REVISIONS TO CONTRACT DOCUMENTS:

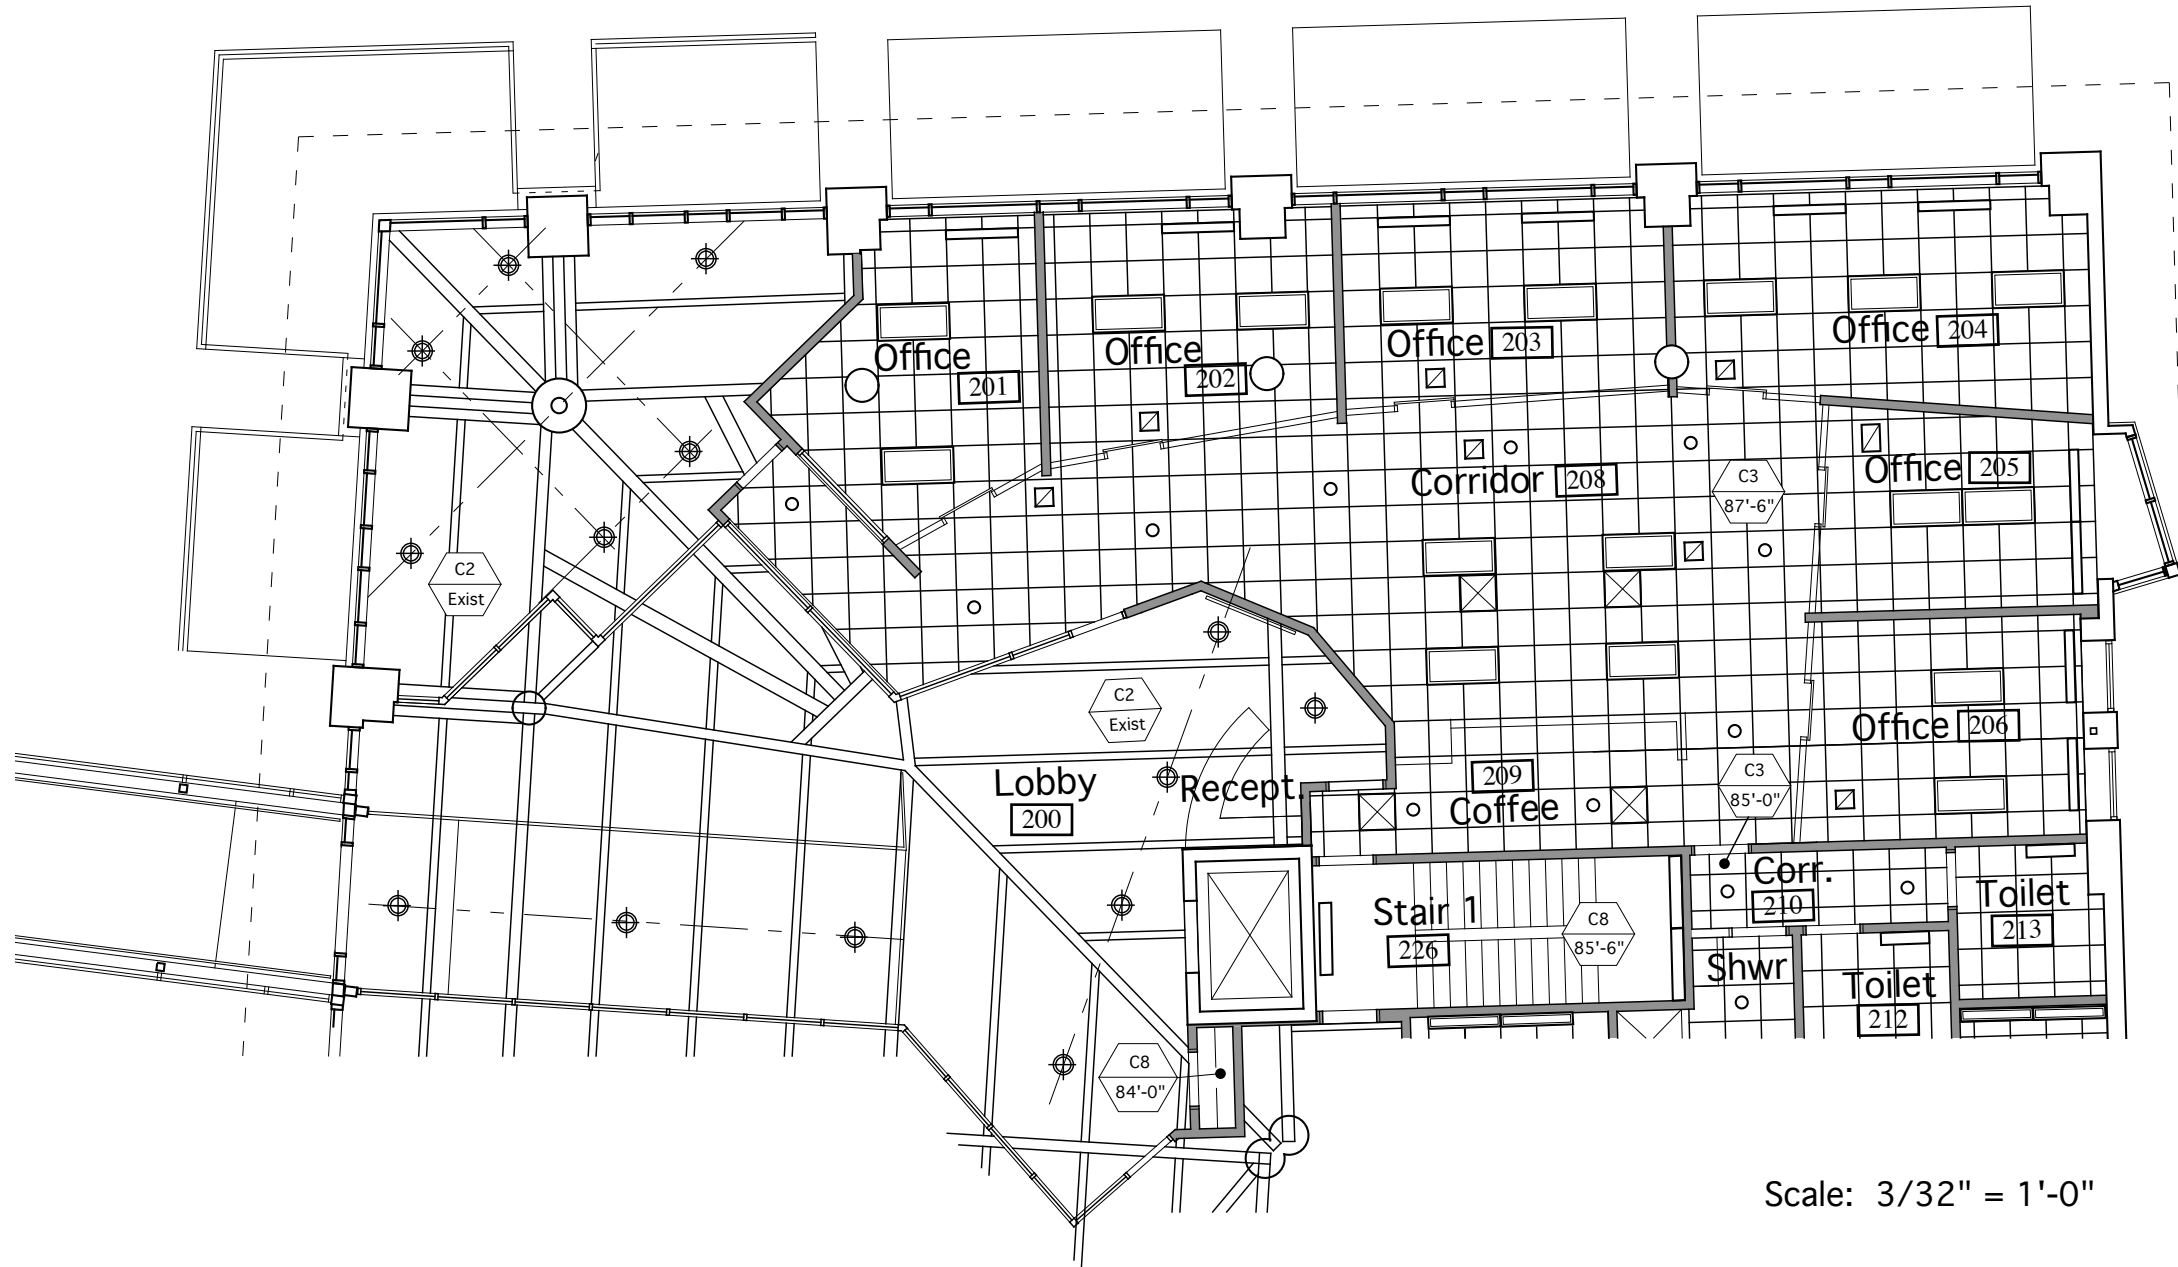
1. Revise layout at office area and add new Conference Room 201A as shown in Plan.
2. Door Schedule Revisions:
 - Delete Door and Frame 207.
 - Change Door 200 from Solid Core Wood with Hollow Metal frame to Aluminum door & frame. Door size to remain 7'-6" H x 3'-0" W.
 - Add new Door and Frame 201A. Door to be Solid Core wood, Type 'D', Frame to be Hollow Metal.

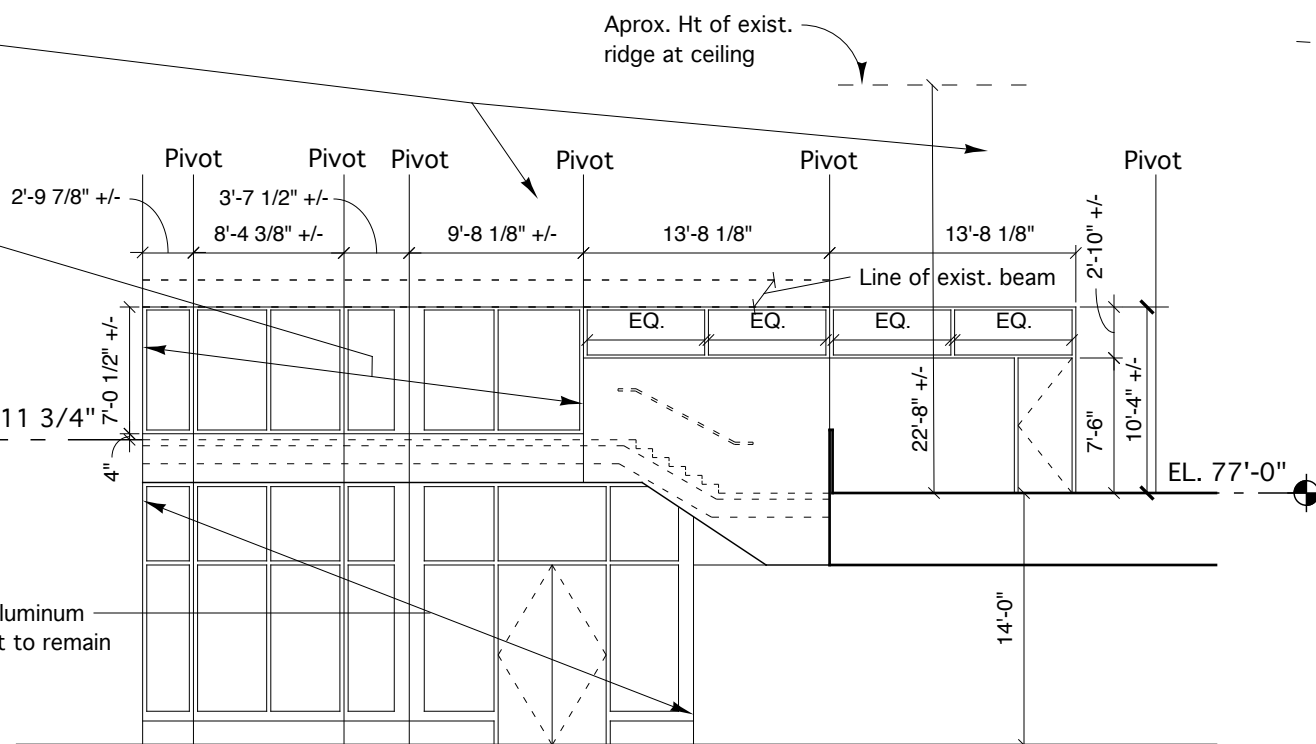
Partition Type 1 to extend up to underside of sloped and flat pine board ceiling above.

New aluminum storefront. Head location is as required to clear bottom of exist'g steel beam running diagonally between columns A2/N8 & E2/N10. Storefront sill to be located 4" above finish floor. Adjust storefront height if required based on field verified dimensions. Vertical mullions to match dimension of and align with exist. vertical mullions below.

FIRST FLOOR CEILING PLAN

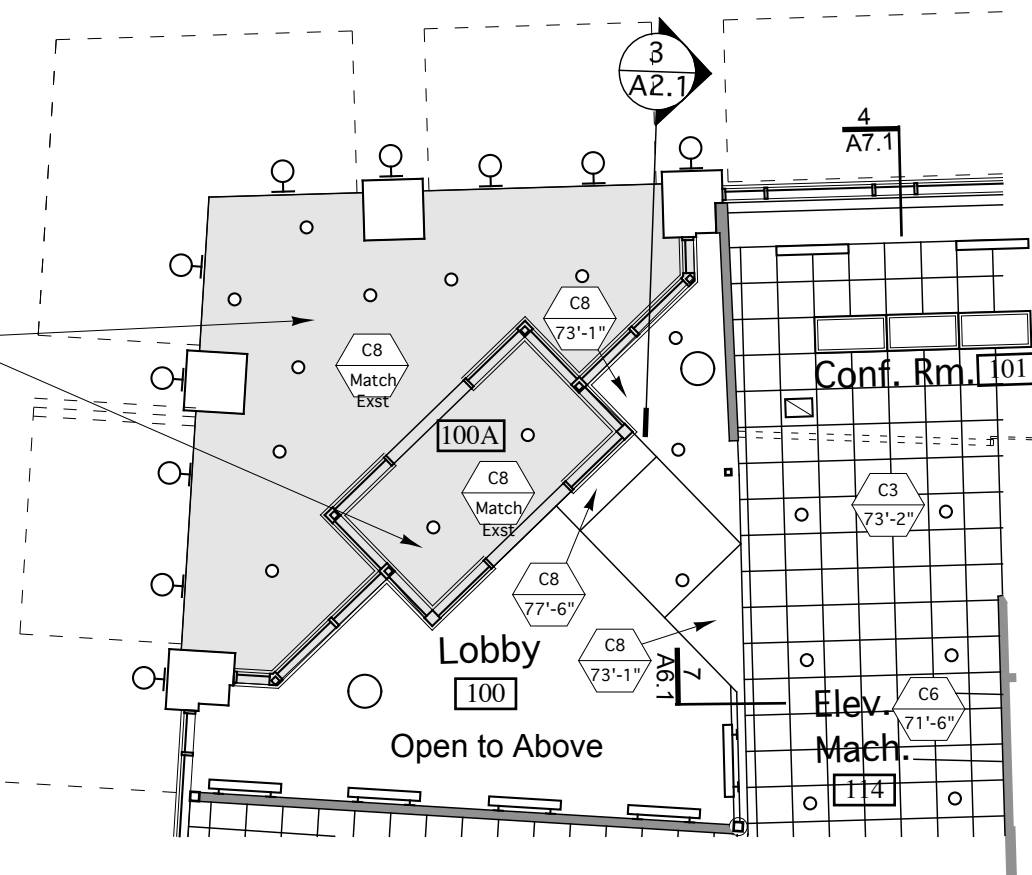
Shaded area represents extent of spray foam insulation to be applied to underside of metal deck per Section on Page 5. Existing Gypsum soffit board ceiling and GWB vestibule ceiling shall be removed and new ceilings installed at same location.

3.4 INTERIOR STOREFRONT ELEVATION
SCALE: 1/4" = 1'-0"

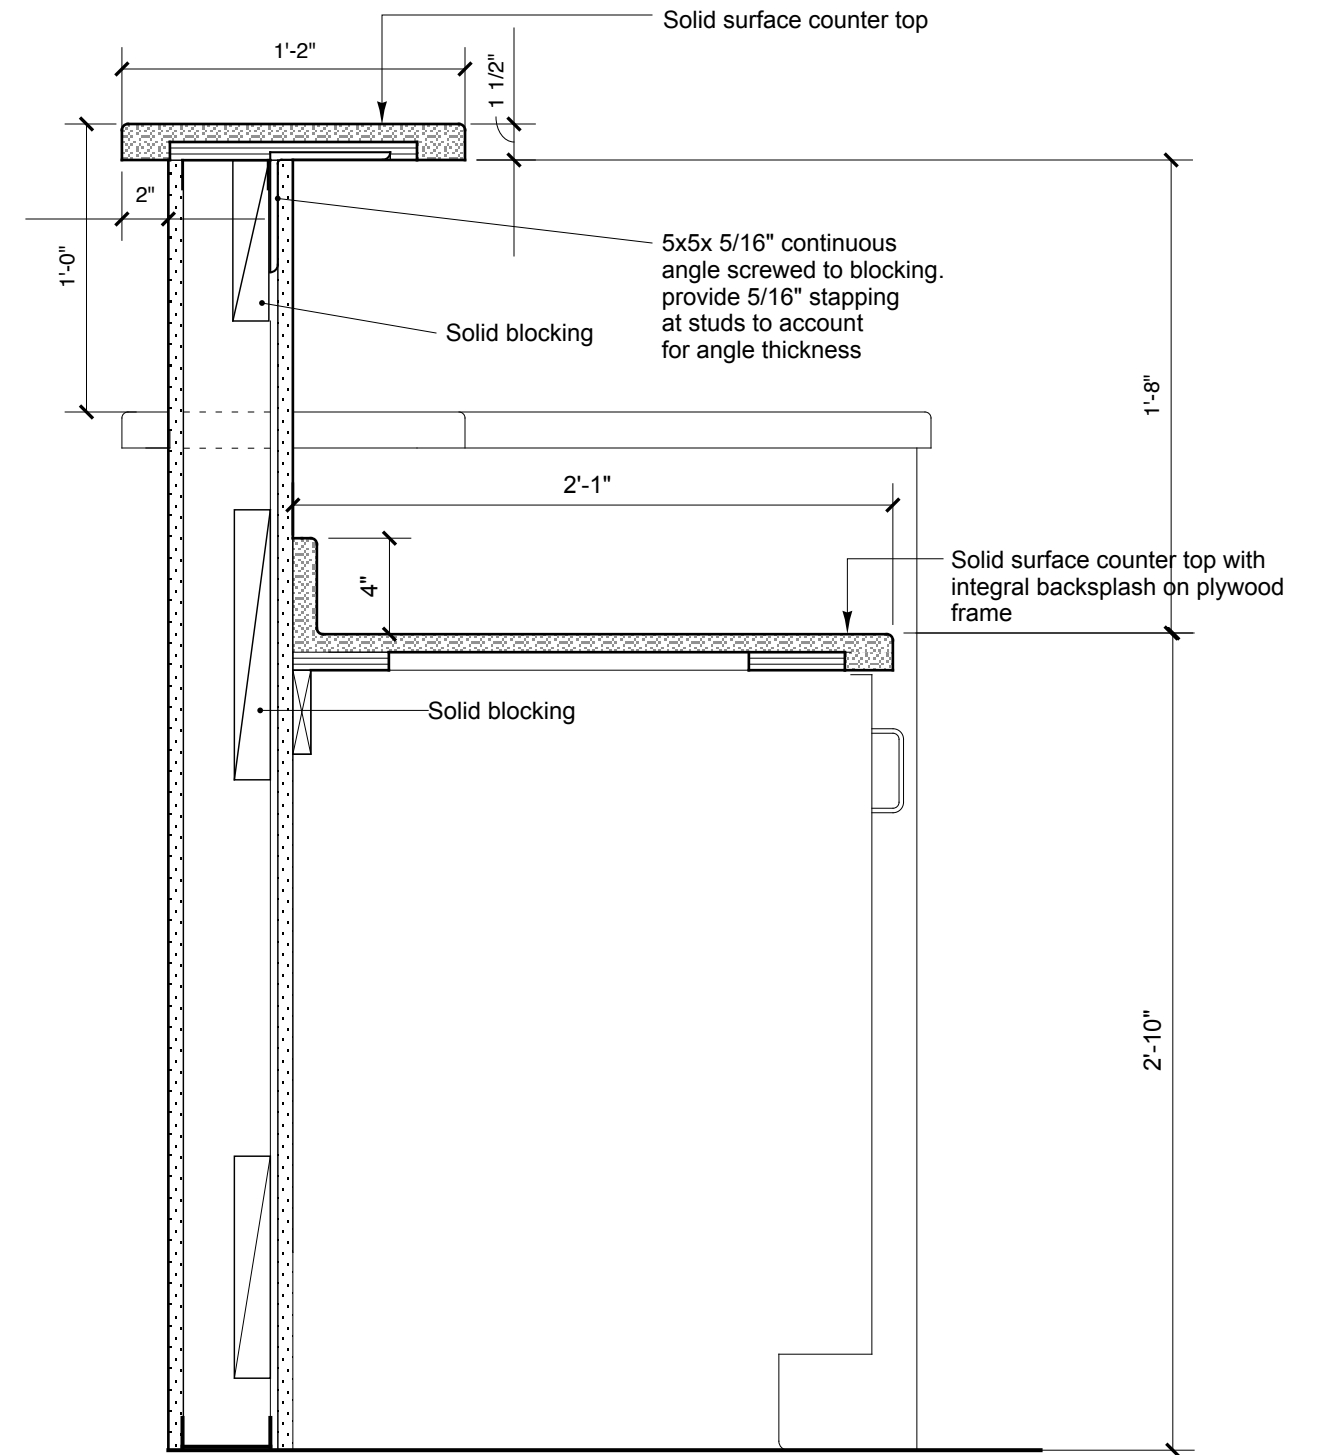
Width to match width of single lite at interior storefront 3.4
